MAINE TURNPIKE AUTHORITY

ADDENDUM NO. 2

CONTRACT 2022.08

LITCHFIELD 8-BAY GARAGE REPLACEMENT

SHEET NUMBER: C-102

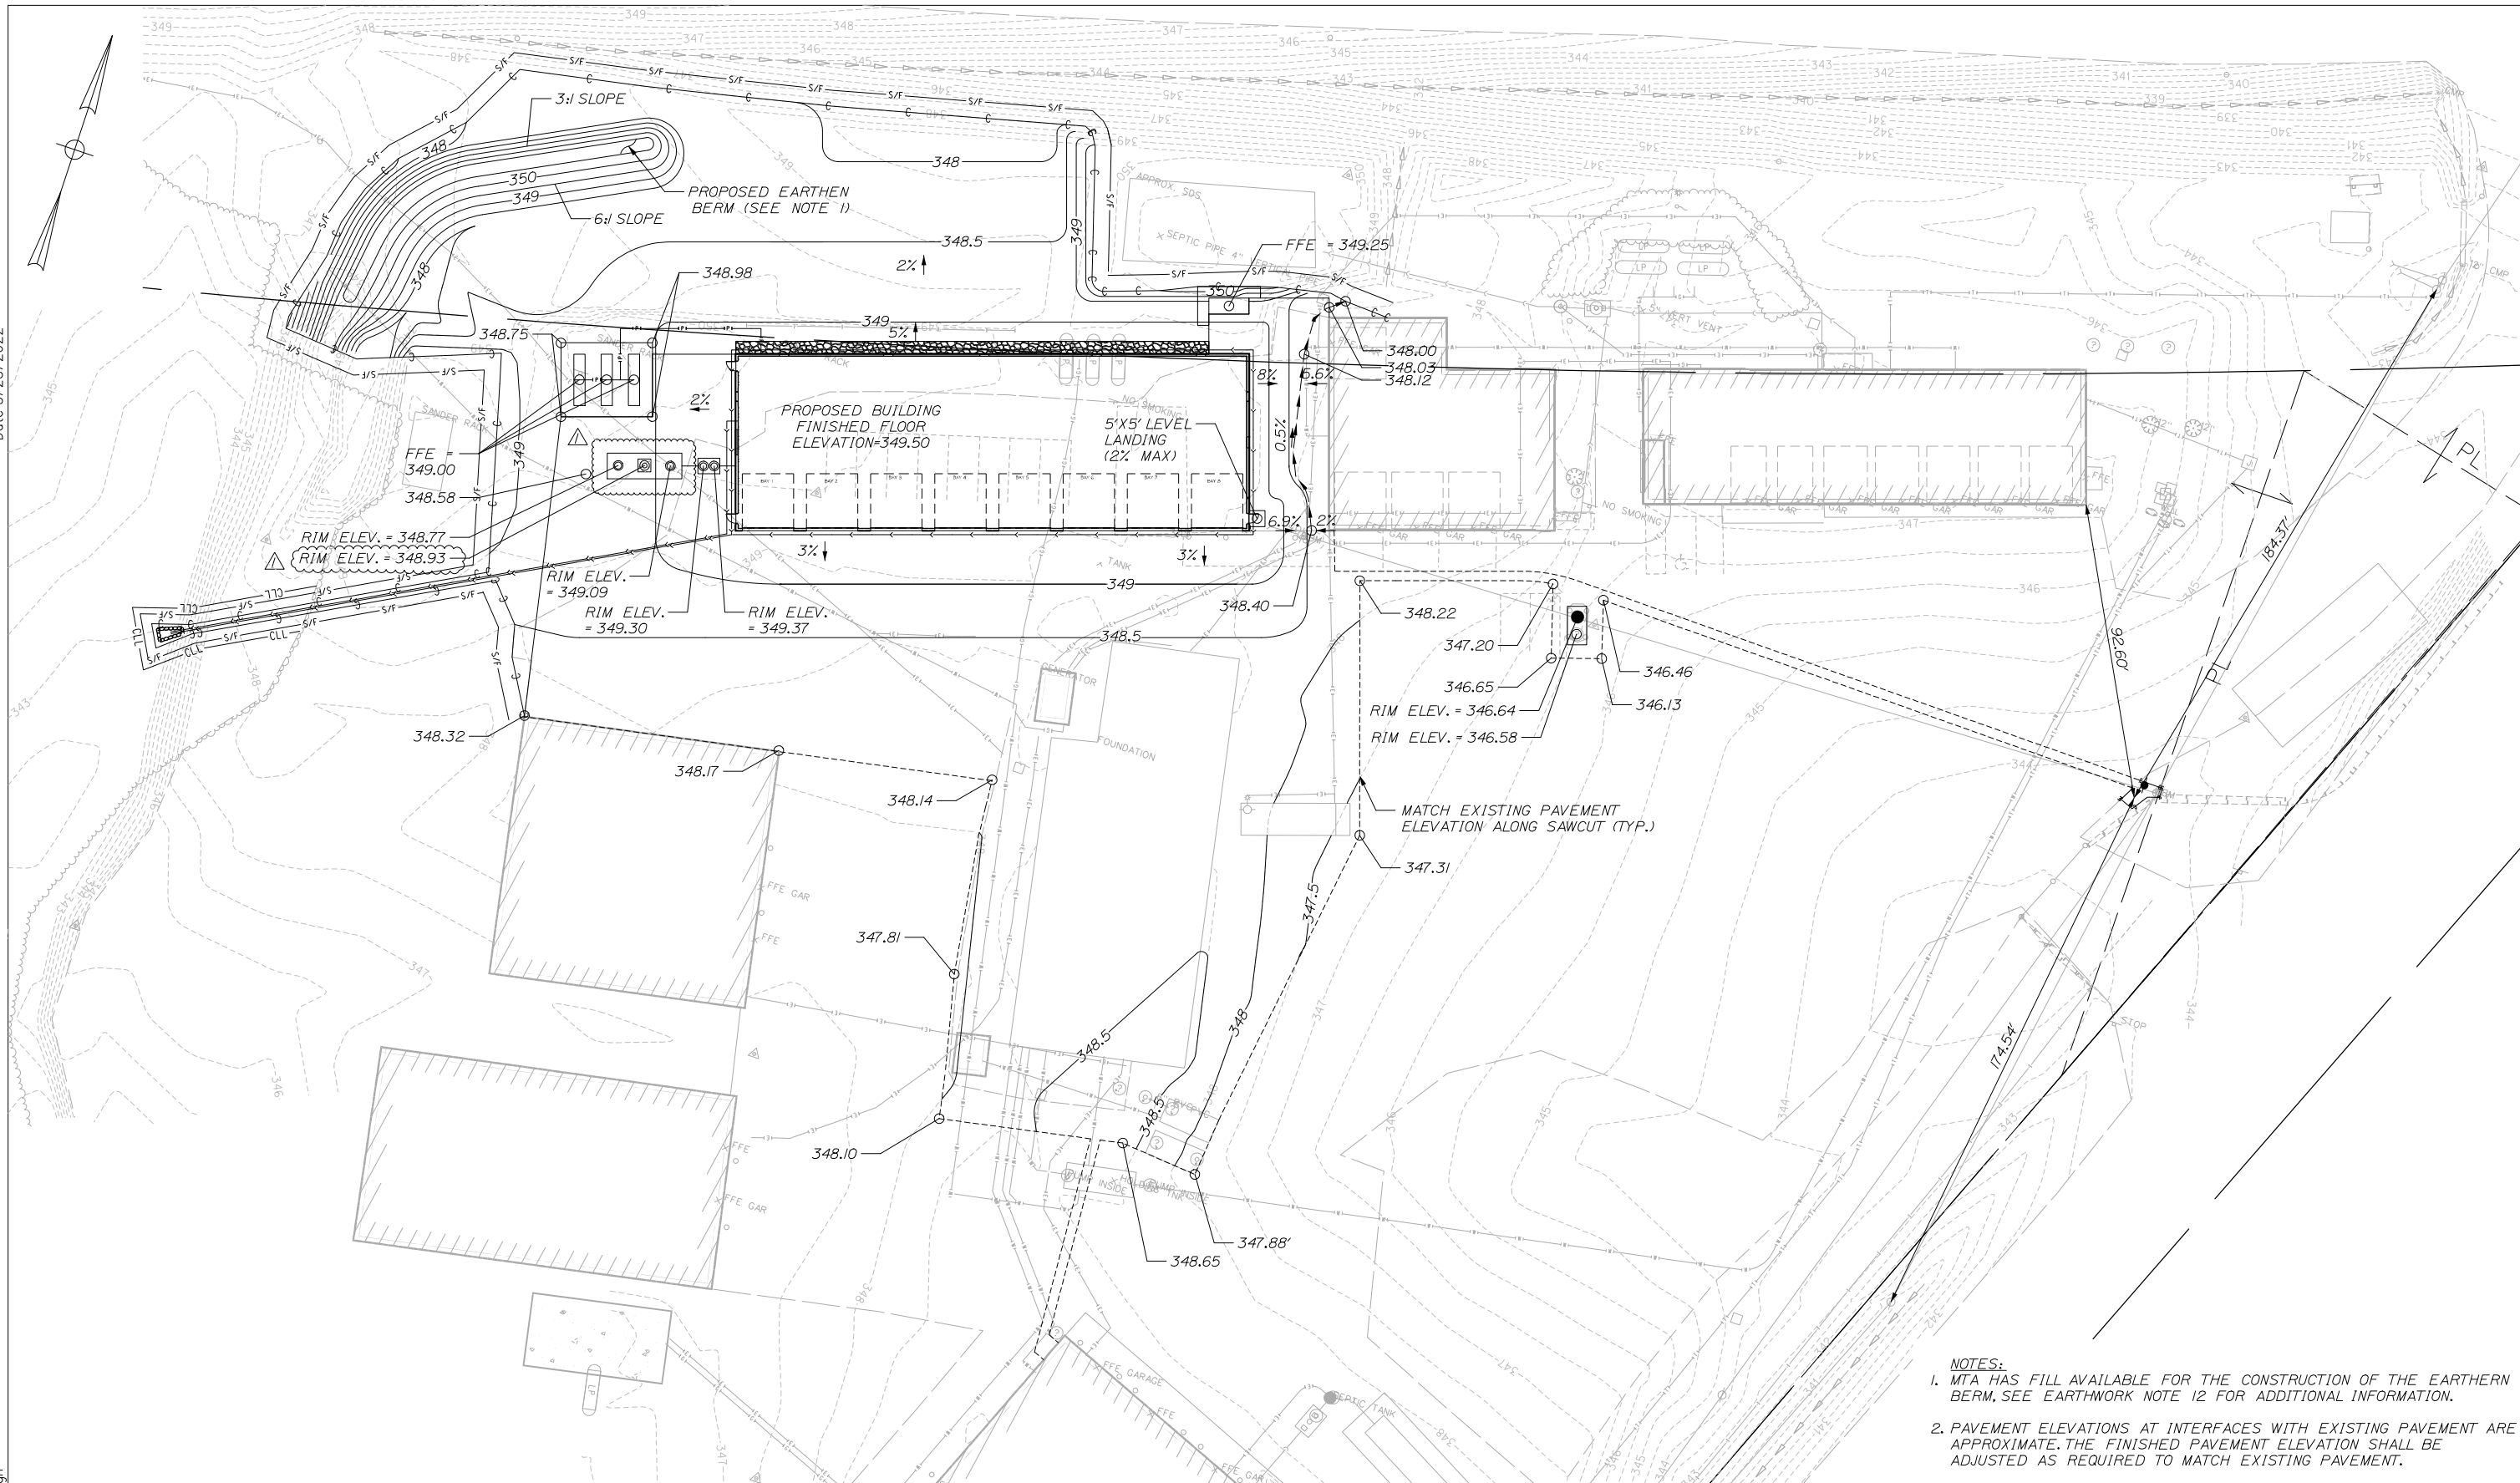
Question 8: On sheet C-102, What is the purpose of the line with a "C" on it. – See left hand side of the page. Is it a clearing limit?

Answer: The C linestyle on sheet C-102 is the limits of grading and indicates a location of cutting/excavation. There is a small area of clearing also shown at the underdrain outlet location to the west of the proposed building with the CLL linestyle (clearing limit line).

SHEET NUMBER: C-404

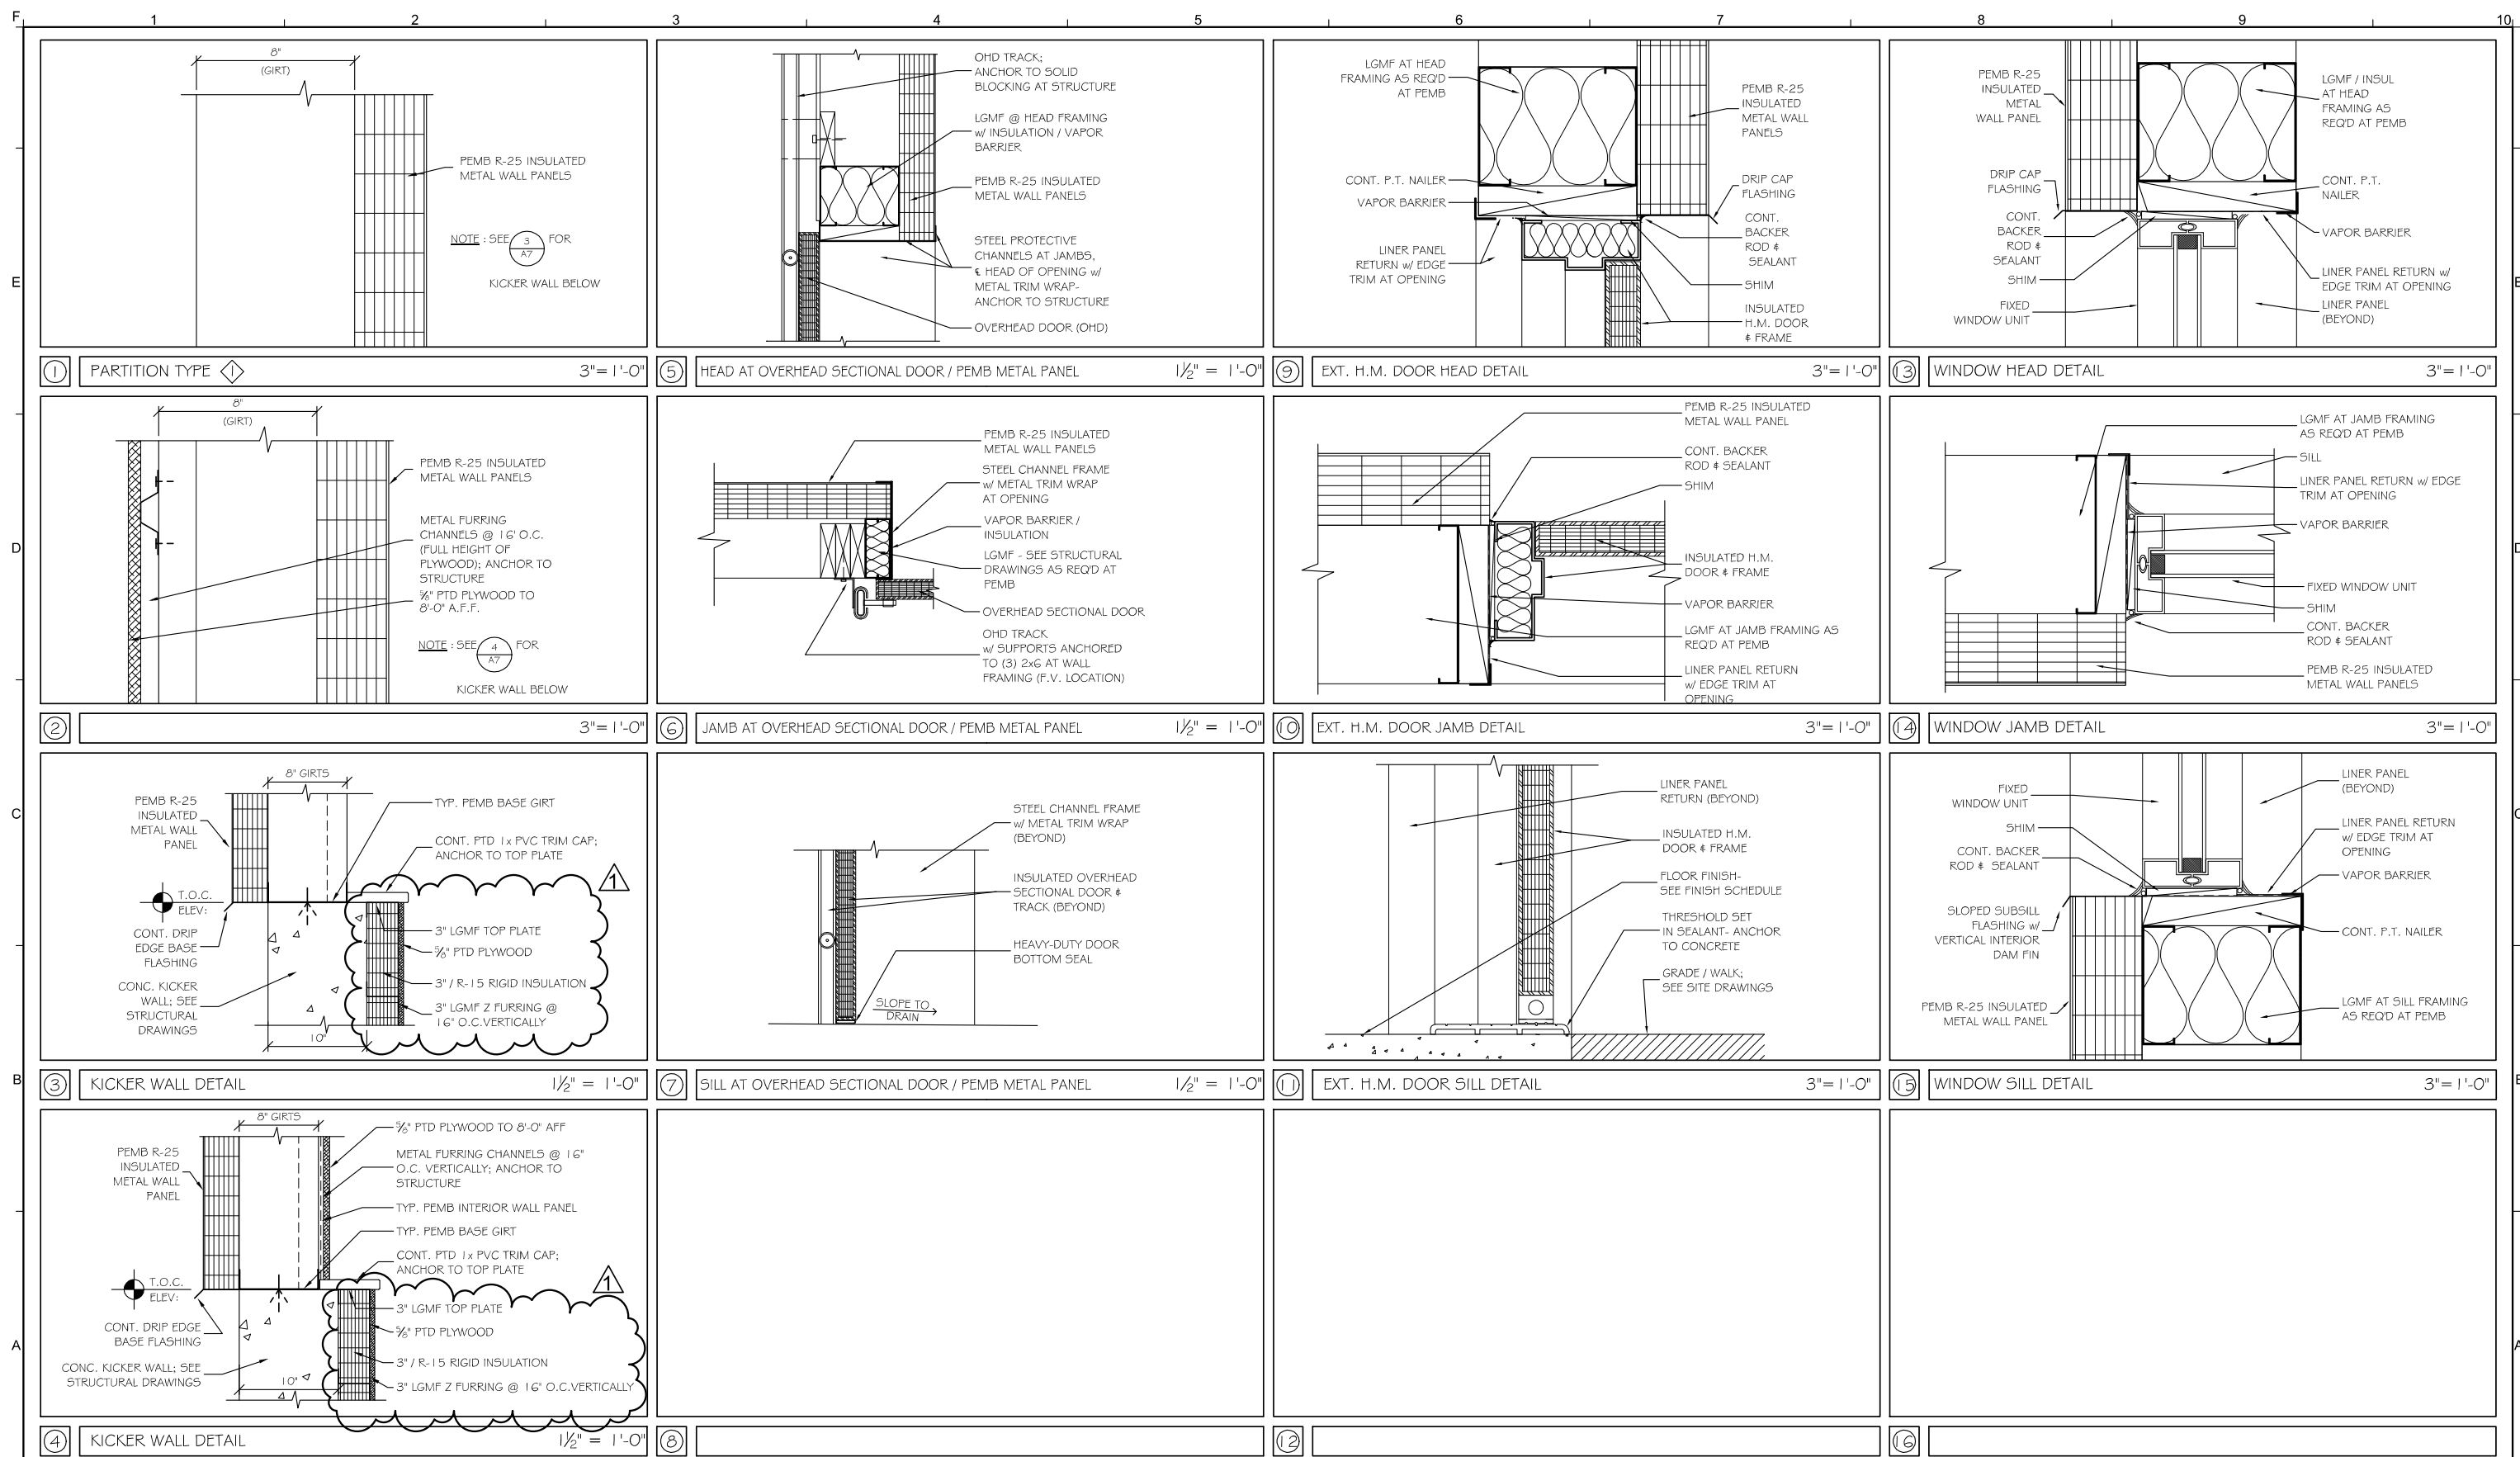
- Plan Sheet 9 – Oil/Water Separator Detail: **DELETE** the sheet and **REPLACE** it with, Plan Sheet 9, attached hereto with revisions.
- Plan Sheet 18 – Details: **DELETE** the sheet and **REPLACE** it with, Plan Sheet 18, attached hereto with revisions.
